DOG RIVER PARK SUBDIVISION, FIRST ADDITION TO, BLOCK C. RESUBDIVISION OF LOT 8

Engineering Comments: FINAL PLAT COMMENTS (should be addressed prior to submitting the FINAL PLAT for review and/or signature by the City Engineer):

APPLICATION NUMBER 4 DATE May 6, 2021

DETAIL SITE PLAN

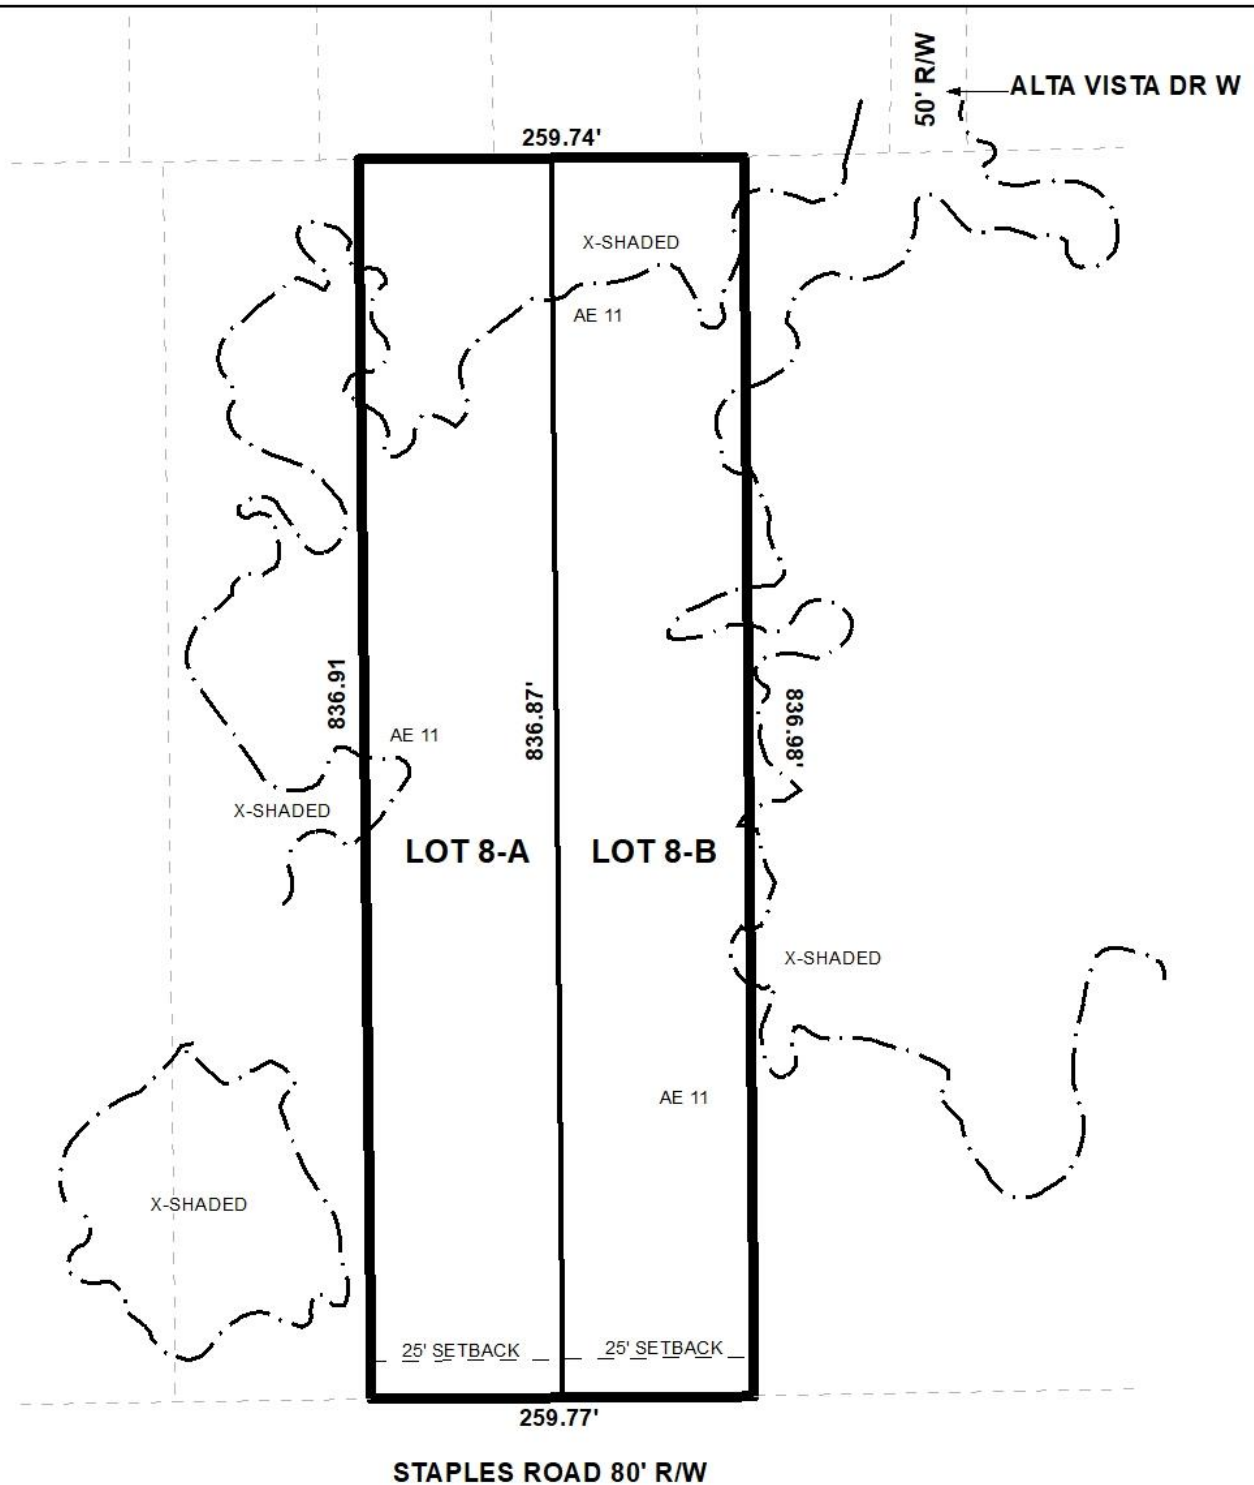
The site has frontage on Staples Road, a minor street without curb and gutter, and with a compliant 80' right-of-way; therefore, no dedication would be required. The right-of-way width should be retained on the Final Plat, if approved.

The plat indicates a 25' minimum building setback line along Staples Road, and this should be retained on the Final Plat, if approved. The proposed lots meet the minimum size requirements of the Subdivision Regulations. As on the preliminary plat, the lot size labels in both square feet and acres should be retained on the Final Plat, or a table should be furnished on the Final Plat providing the same information.

As proposed, the lots exceed the depth-to-width ratio of Section V.D.3. of the Subdivision Regulations. However, as there are other similar lot within the area approved via subdivisions by the Commission, a waiver of this section would seem in order.

There is an existing dwelling on the site. This structure must maintain compliant setbacks on the Final Plat or be demolished prior to signing the Final Plat.

- 1) retention of the right-of-way width of Staples Road on the Final Plat;
- 2) retention of the 25' minimum building setback line on the Final Plat;
- 3) retention of the lot size labels in both square feet and acres on the Final Plat, or the furnishing of a table on the Final Plat providing the same information;

- 4) either illustration of the existing dwelling in compliance with setback requirements on the Final Plat, or obtaining of a demolition permit and removal of the dwelling prior to signing the Final Plat;
